1990 Corvette: Service Bulletin: ABS Code 63 Revised Diagnostic Chart

Subject: SERVICE MANUAL UPDATE SEC. 5E1 ABS DIAGNOSIS-
REVISED CODE 63

Model and Year: 1990 CORVETTE

Bulletin Number: 90-430-5 - (08/21/1991)

CODE 63
(PAGE 1 OF 3)
SOLENOID VALVE RELAY
(RELAY FAULT)

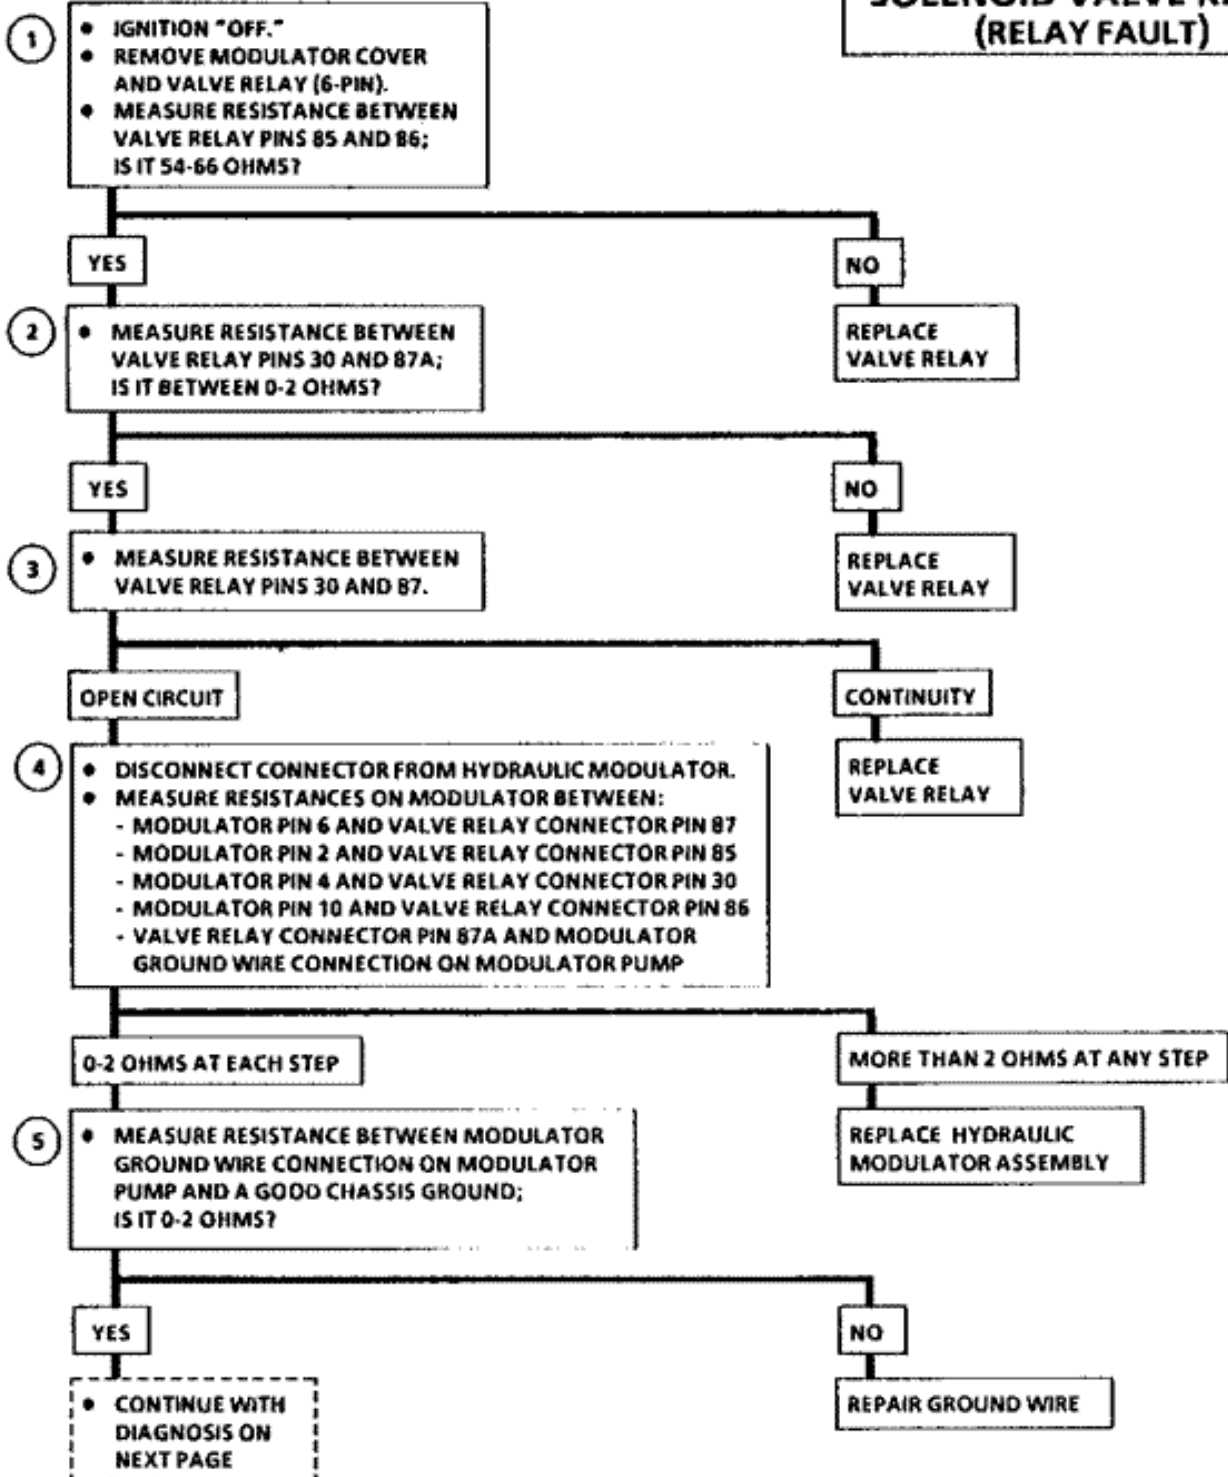
This bulletin serves to update the ABS Code 63 (Page 1 of 3) diagnostic chart on page 5E1-37 in Section 5E1 "Antilock Brake System Diagnosis" of the 1990 "Y" Service Manual. Please use the attached revised Code 63 (Page 1 of 3) diagnostic chart when diagnosing ABS Code 63 conditions on 1990 Corvettes.
